In the Matter of
FLORIDA POWER & LIGHT COMPANY
(St. Lucie Nuclear Power Plant, Unit 2)
Docket No. 50-389

SUBJECT: ADEQUACY OF REACTOR COOLANT PUMP SEAL DESIGN DURING POSTULATED
STATION BLACKOUT CONDITIONS
(St. Lucie Plant, Unit No. 2)

NRC STAFF TESTIMONY

ROBERT G. FITZPATRICK

Figure A1
Basic Requirements of GDC 17

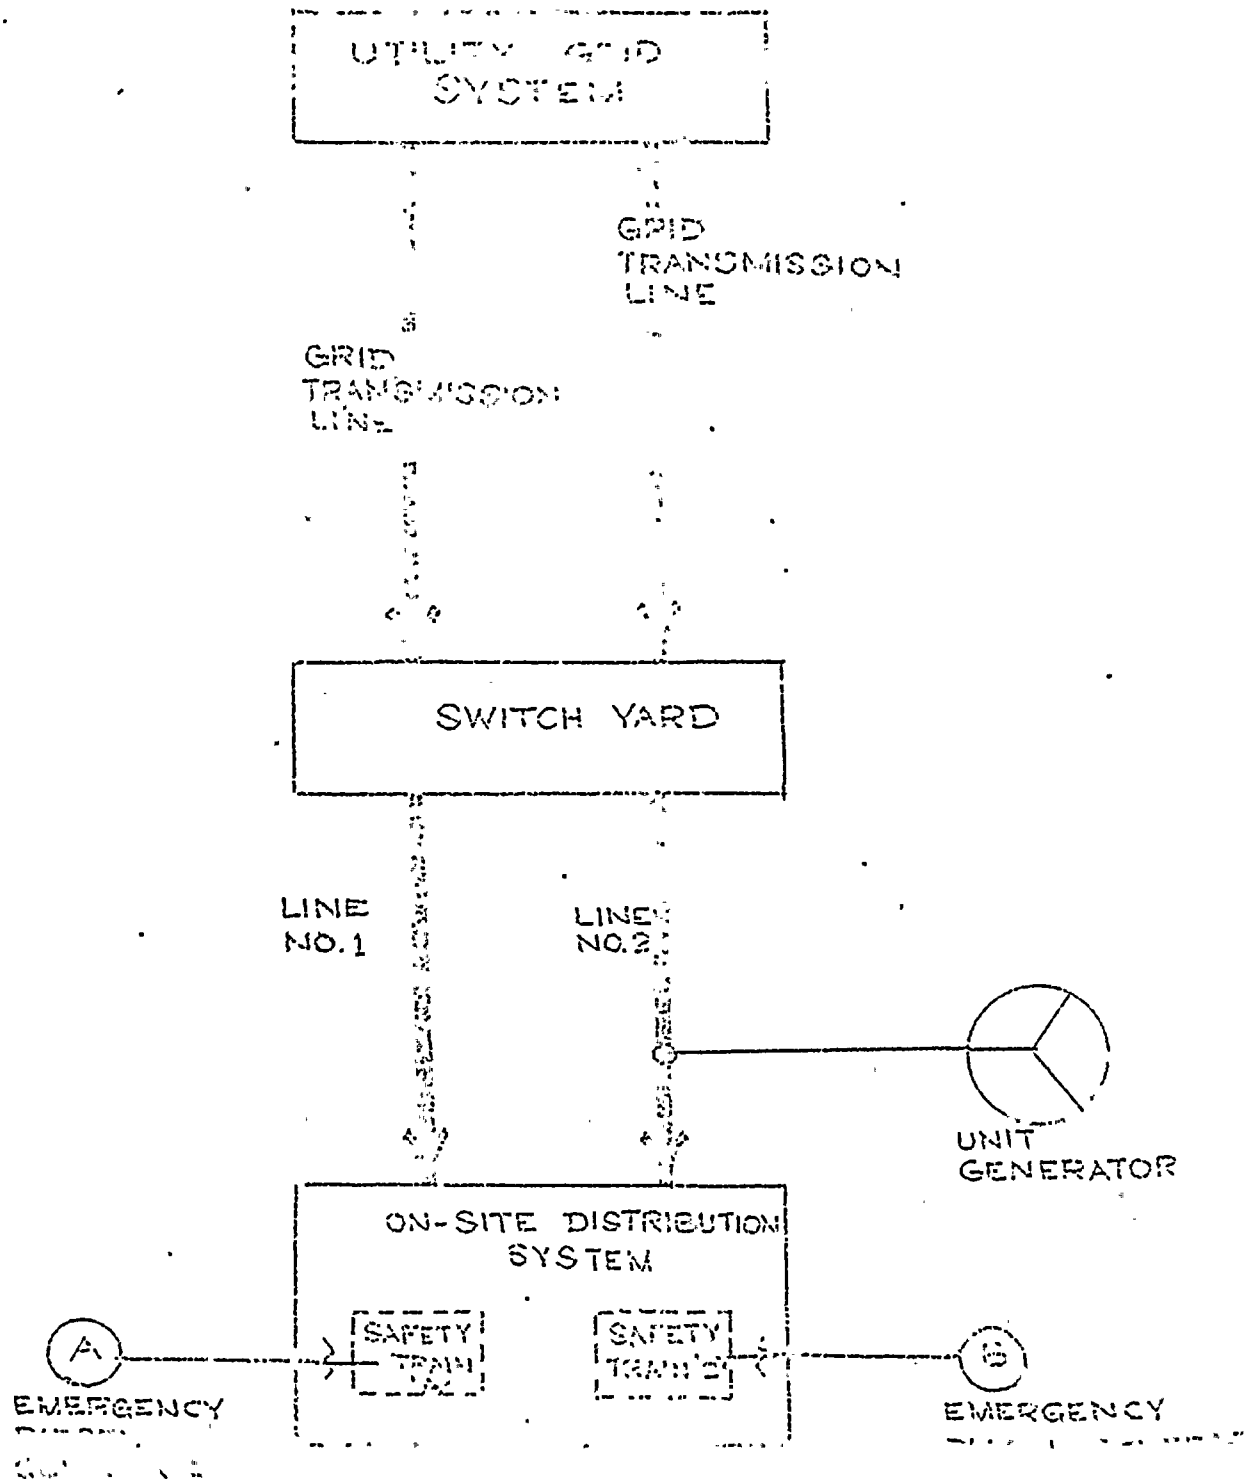
Applicant also provides an analysis of what changes in reliability could be gained by bringing one of the St. Lucie transmission lines directly to the Ranch Substation.^{3/} The analysis appears to be carefully constructed to demonstrate no reliability can be gained by a physical change in the grid system. The staff is not convinced that the modified design, as presented, is the design that the applicant would choose if the Appeal Board should require a grid connection for St. Lucie at other than the Midway Substation. A seemingly much more practical approach would have been to investigate what lower voltage distribution systems in the area of St. Lucie could be tapped for a connection to the nuclear units. This concept would leave the three St. Lucie to Midway lines intact with no reduction in present reliability and would provide a relatively low cost alternative way to supply St. Lucie a grid connection at other than the Midway Substation with a definite increase in overall reliability.

The following is a hypothetical example of a way of providing a separate connection to grid other than at Midway. (The viability and practicality of this or any other hypothetical example would ultimately have to be determined by the applicant.) The source of this example is the grid configuration figure presented in attached #6 to the applicants testimony on this question. There is a 138Kv right-of-way that crosses the St. Lucie-Midway lines and goes between White City and Jensen. This line could be tapped at its intersection with the St. Lucie to Midway lines. Additional

circuit breakers at this end of the line would not be necessary. Because the St. Lucie to Midway lines would not be altered and the existing design already meets GDC-17 requirements, this 138Kv line could be run on one of the three existing lines of transmission towers. This is particularly important as there is only one right of way allowed to the applicant for crossing from the mainland to Hutchinson Island. Termination at St. Lucie would require a transformer and some 4Kv switchgear. This line would not be required for bulk power output from the generating units and therefore could be dedicated to the emergency buses with a required power transfer capability equal to the combined emergency loads of the two units. This transfer capability is well within the limits of a 138Kv line. I do not believe it is necessary to make this or any similar modification to the St. Lucie design, however, this is the type of analysis (with further supporting details) that I would have expected from the applicant.
